Leeds
CITY COUNCIL

CITY PLANS PANEL

Subject: LAND OFF SOVEREIGN STREET, LEEDS LS1

12/04017/LA CHANGE OF USE FROM CAR PARK TO PUBLIC REALM AND AMENITY SPACE, TO INCLUDE PAVING, WATER FEATURE, DRAINAGE, EXTERIOR LIGHTING AND ASSOCIATED SOFT LANDSCAPING WORKS

Plan 2 – Superseded Site Layout General Arrangement RF12-0650L02

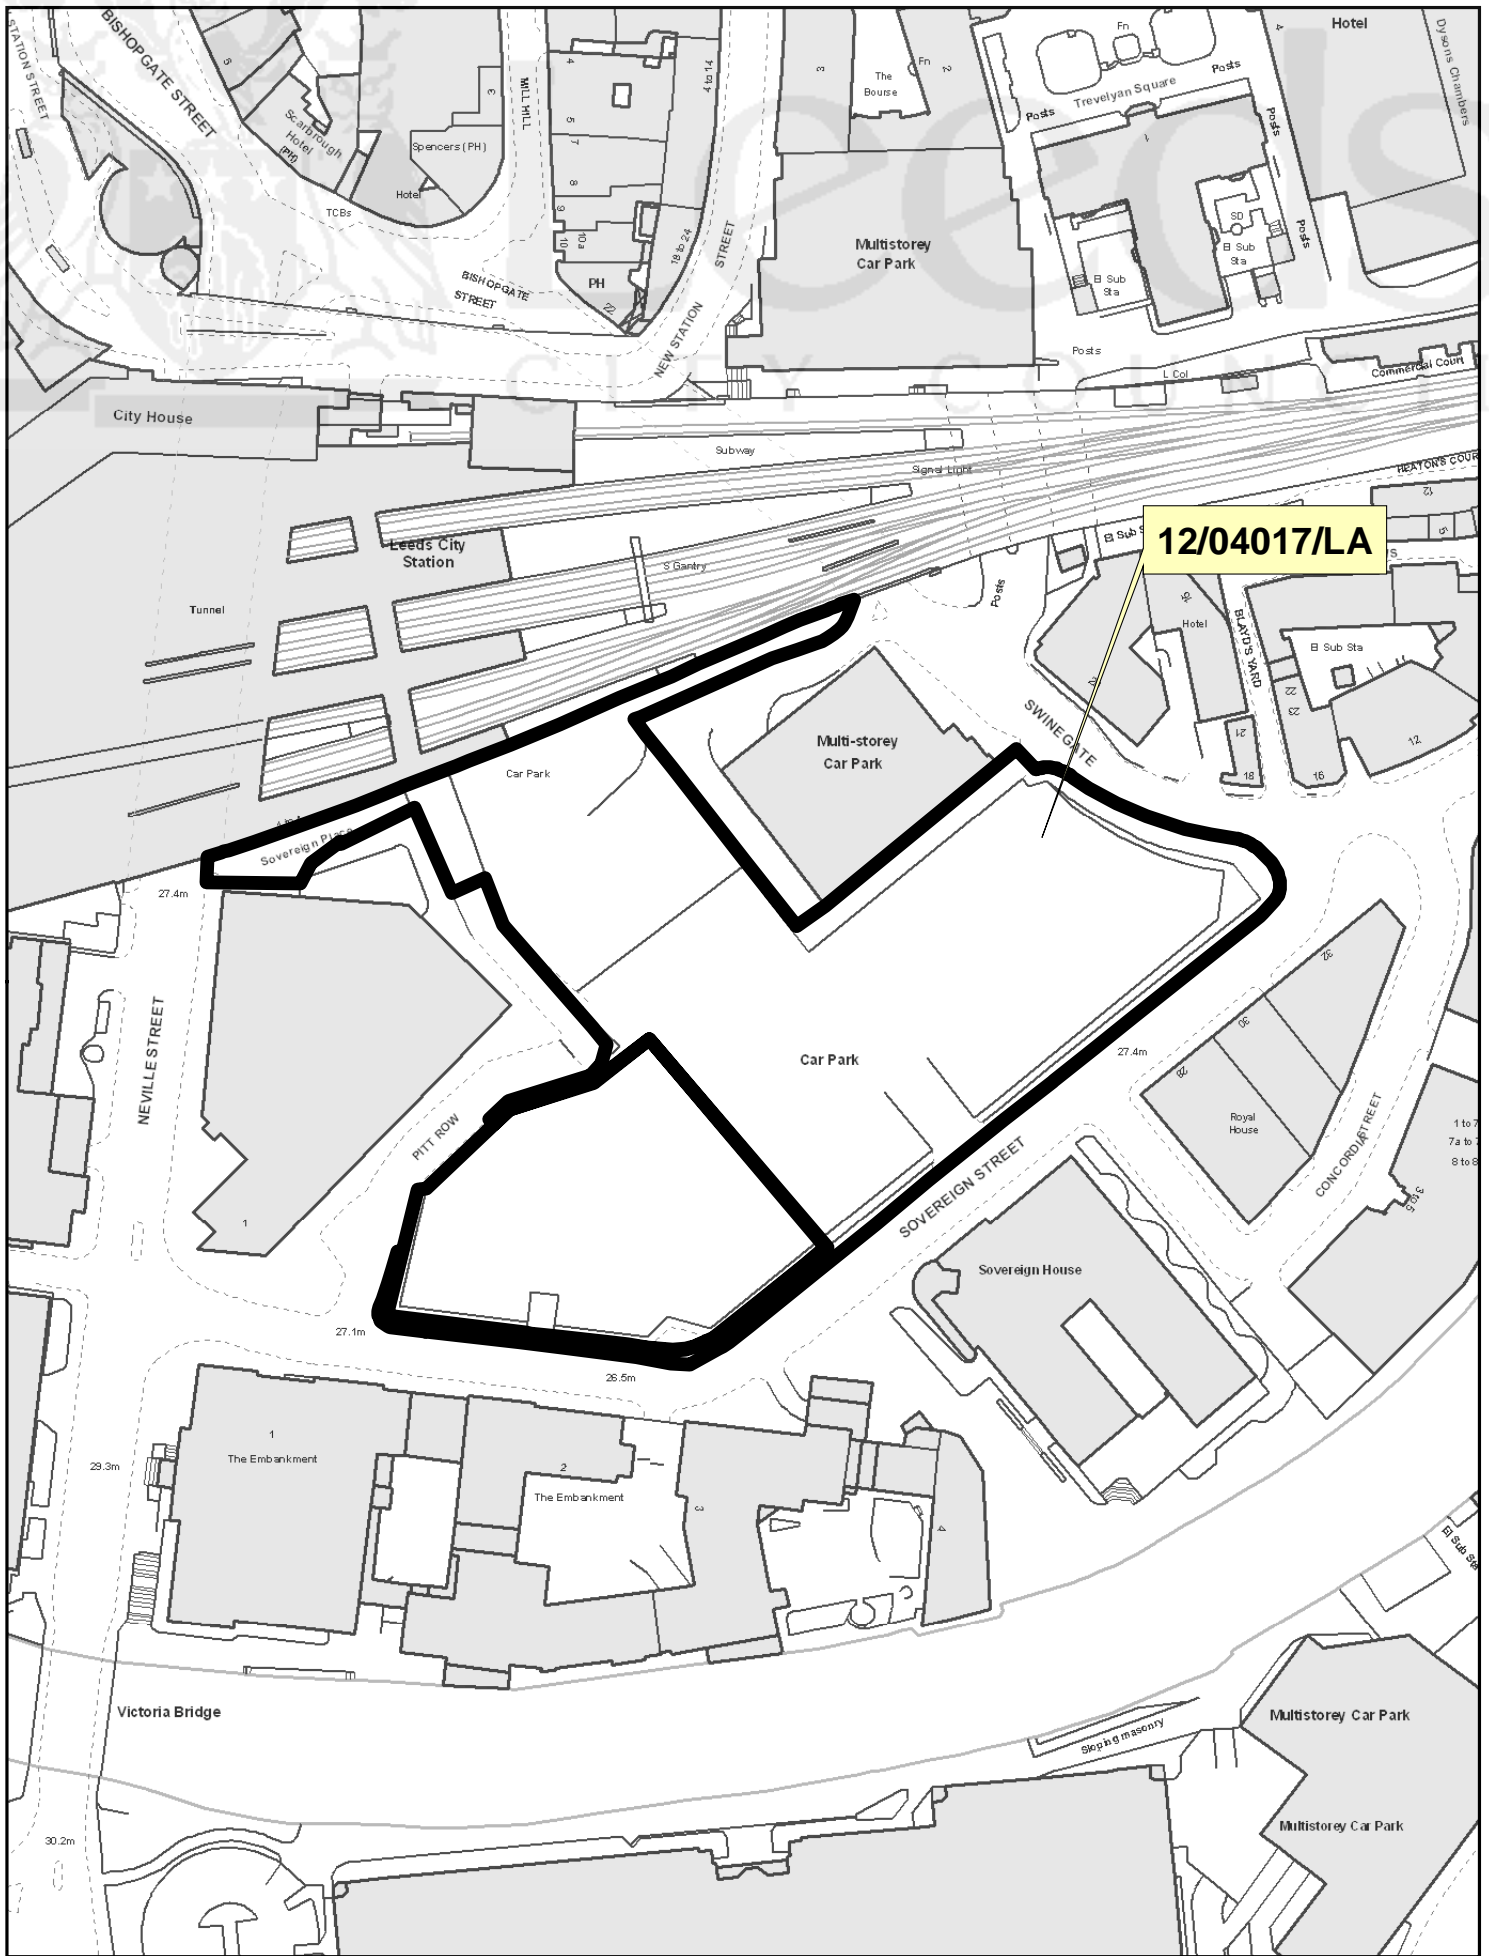
- 10.2.1 In response to Members' comments, a number of changes have been made to the proposed scheme. The overall size of the application site has increased from 6000 sqm to 7000 sqm through the reduction in the size of Plot C, and the addition of areas at the north western corner of the site. The balance of hard and soft landscaping has now increased by some 30% up to approximately 67% soft landscaping.

- 10.2.2 There has been an increase in size of greened areas within the scheme, as shown on the revised General Arrangement Plan revision B. The main grassed square is now some 35m x 42m with a 2m footway in between to allow pedestrian access through the site in all weathers. This has increased from approximately 22m x 28m.

- 10.2.3 The Raingarden is now some 54m x 14m of dense planting, interspersed with seating areas. A new 12m x 16m area of planting has also been added to the rear of Plot B, and new landscaped border to edge of BT building to complement the improvements to the City House car park access road and enhance the approach from Neville Street/Sovereign Place.
